SUBJECT: CATAWBA NUCLEAR STATION, UNIT 1, ISSUANCE OF EMERGENCY  
AMENDMENT REGARDING ONE-TIME EXTENSION OF THE 1B CHARGING  
PUMP AND THE AUXILIARY BUILDING FILTERED VENTILATION EXHAUST  
SYSTEM ALLOWED OUTAGE TIME (TAC NO. MD7563)

SAFETY EVALUATION BY THE OFFICE OF NUCLEAR REACTOR REGULATION

AMENDMENT NO. 239 TO RENEWED FACILITY OPERATING LICENSE NPF-35

CATAWBA NUCLEAR STATION, UNIT 1

Catawba 1 1B NV Pump

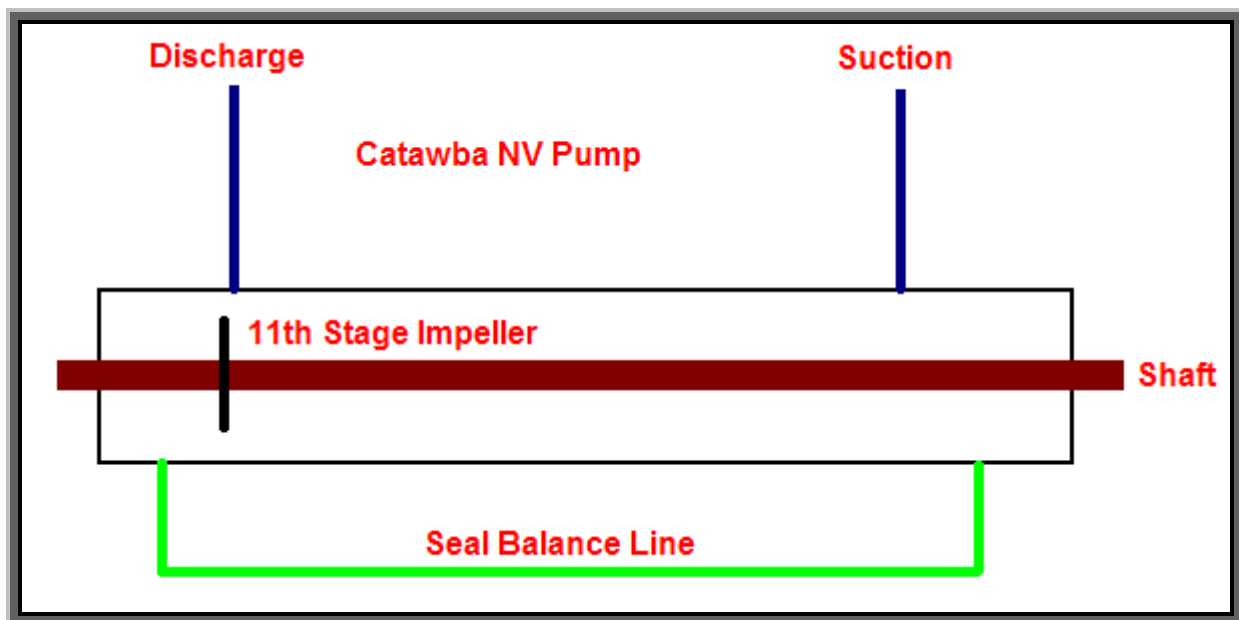
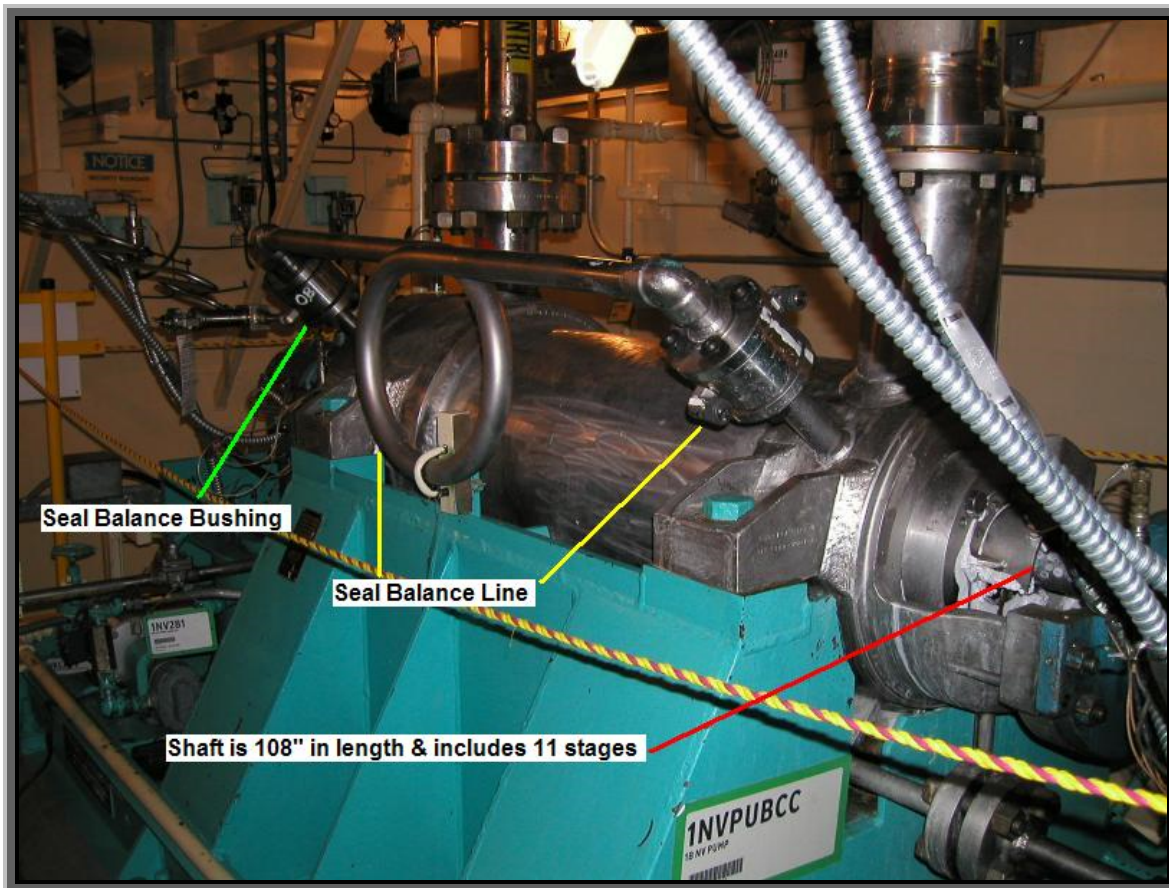
On December 30, 2007, the licensee noted, increased differential pressure (dP) readings on the seal balance line for the 1B NV pump. The seal balance line connects a bushing located after the 11<sup>th</sup> stage impeller (the last one) of the NV pump back to the suction side of the pump and is designed to reduce the loading on the outboard seal package and the thrust bearing. See the diagram below. In the event there is a problem internal to the pump, the flow back through the balance bushing will be adversely affected and the dP (pressure after the 11<sup>th</sup> stage impeller vs. the suction pressure) will show an increase. The licensee reviewed recent data recorded each shift, the dP has increased from a fairly consistent value of ~20 pounds per square differential (psid) to ~35 psid.

The motor stator temperatures of the 1B NV pump have also shown an increase. Any problems internal to the pump would require more motive force to get the same flow and hence the increased motor stator temperatures reflected in the measured values which tend to confirm the suspected impending failure of the NV pump shaft.

Late on December 30, 2007, local panel indications for high vibration were received and these were then confirmed by licensee maintenance personnel. The largest increase over data taken on December 19, 2007, during a routine surveillance test was on the outboard bearing in the vertical direction which went from a value of ~0.95 mils peak-to-peak to the measured value on December 31, 2007, of ~1.6 mils peak-to-peak.

The licensee entered vibration data into a computer code which graphed the shaft turning speed / displacement in vector format and this confirmed that the shaft is showing an increase in amplitude movement
